## Development Services Staff Report

<b>File Number</b>	PL2022-216
<b>File Name</b>	Continued PRELIMINARY DEVELOPMENT PLAN – Macadoodles
<b>Applicant</b>	KC Blitz, LLC dba Macadoodles
<b>Property Address</b>	1499 SW Market St
<b>Planning Commission Date</b>	September 8, 2022
<b>Heard by</b>	Planning Commission and City Council
<b>Analyst</b>	Hector Soto, Jr., AICP, Senior Planner
<b>Checked by</b>	Kent Monter, P.E., Development Engineer Manager

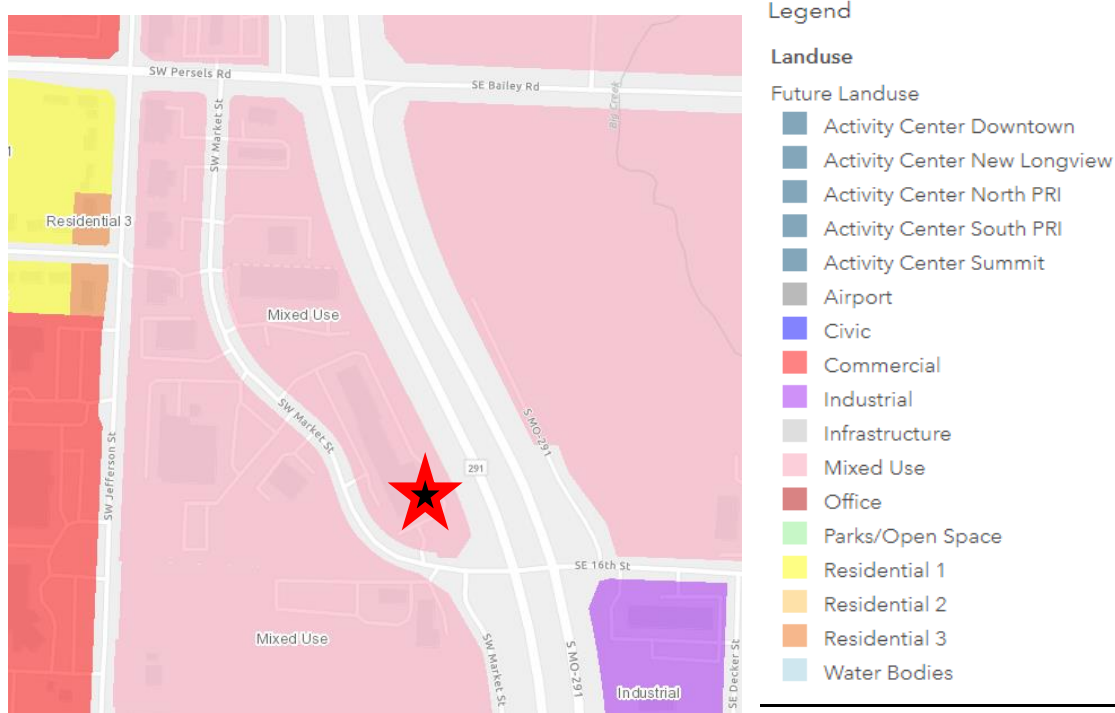
The scope of the site improvements associated with the subject application are clouded above for reference. The improvements include construction of a drive-through lane on the south side of the existing building and the relocation of six (6) parking spaces displaced by the proposed drive-through. The displaced parking spaces will be distributed between two areas along the retail center's M-291 Hwy frontage. The proposed improvements result in the need for two modifications that are addressed under staff's analysis.

- Required – Parking lots shall be set back a minimum 20' from the public right-of-way.
- Proposed – The relocation of two (2) parking spaces to the southeast corner of the existing parking lot results in a setback of 4'-4" from the M-291 Hwy right-of-way.
- Recommendation – At its closest point, the existing parking lot is set back 5'-9" from the M-291 Hwy right-of-way line and is set back approximately 67' from the nearest edge of pavement of the southbound M-291 Hwy travel lanes. The subject lot is irregular in shape and tapers down in width from north to south due to the curvilinear nature of the abutting M-291 Hwy and SW Market St rights-of-way. The relocated parking spaces maintain the existing parking lot boundary curb alignment for the site, but the abutting highway starts to turn back toward the site and thus results in a reduction to the setback. The proposed

reduction in existing setback by 1'-5" does not significantly alter existing site conditions and still yields a substantial separation of approximately 65' between the parking lot and nearest M-291 Hwy travel lanes. Staff supports the requested modification.

- Required – Two-way drive aisles adjacent to 90-degree angled parking spaces shall have a minimum 24' of pavement width (excluding curb and gutter).
- Proposed – To accommodate the proposed drive-through lane along the south side of the building, the existing parking spaces immediately adjacent to the south side of the building are being shifted slightly to the south, resulting in 22' pavement width (excluding curb and gutter) for the adjacent drive aisle.

- Recommendation – The existing parking lot complies with the minimum 24' of pavement width for the two-way drive aisle throughout the retail center. The applicant's own actions stemming from the proposed construction of a drive-through facility result in the drive aisle pavement width reduction that causes the drive aisle width to fall out of the compliance with the UDO. While the proposed 22' of drive aisle pavement width is sufficient to accommodate two-way traffic circulation through the immediate area south of the building based on an accepted minimum standard that 10'-wide travel lanes provide adequate safety for vehicles, the reason additional pavement width is required for drive aisles with adjacent parking spaces is to provide adequate room to facilitate backing movements out of the parking spaces. Case in point, the UDO allows for only 20' of pavement width for two-way drive aisles where no parking spaces are present along the drive aisle. As proposed, 14 parking spaces on the south side of the building are directly impacted by the proposed reduction in pavement width. To meet the minimum required 24' of pavement width, the southern boundary of the existing parking lot will need to be pushed out 1.5' to 2' to the south.

Included as an attachment is a modification request by the applicant's design professional providing justification for the proposed pavement width reduction to 22'. The applicant wishes to include the curb and gutter to achieve the 24' drive aisle pavement width. However, the UDO explicitly excludes curb and gutter from the drive aisle pavement width measurement. The design professional's modification request states that requiring compliance with the minimum 24' pavement width creates a hardship because the project scope will grow in scale by needing to push out and reconstruct the parking lot's southern curb line. This perceived hardship on the applicant's side to comply with the UDO drive aisle pavement width standard is self-created. As previously stated, the existing parking lot currently complies with the minimum pavement width standards. Similar to how the six (6) existing parking spaces displaced by the drive-through are being relocated in order to remain compliant with the minimum parking requirement for the center, so should the existing south parking lot boundary be altered in order to remain compliant with the UDO's minimum drive aisle pavement width. Staff does not support the requested modification and recommends that the minimum 24' of pavement width (excluding curb and gutter) for a two-way drive aisle be provided for the south parking lot area as required by the UDO. In order to meet the minimum 24' drive aisle pavement width requirement, the southwest corner of the parking lot will require a modification to reduce the existing parking lot setback from 8' to approximately 7' along SW Market St. Portions of the existing parking lot further north on the retail center site currently maintain a 5' setback along SW Market St, so a 7' setback would not be out of character for the subject site.

1. A modification shall be granted to the minimum 20' parking lot setback from right-of-way, to allow a 4'-4" parking lot setback along the site's M-291 Hwy frontage.

2. A minimum 24' pavement width (excluding curb and gutter) shall be provided for the two-way drive aisle located south of the proposed drive-through facility. To meet this requirement, a modification shall be granted to the minimum 20' parking lot setback from the public right-of-way, to allow a 7' parking lot setback along SW Market St.
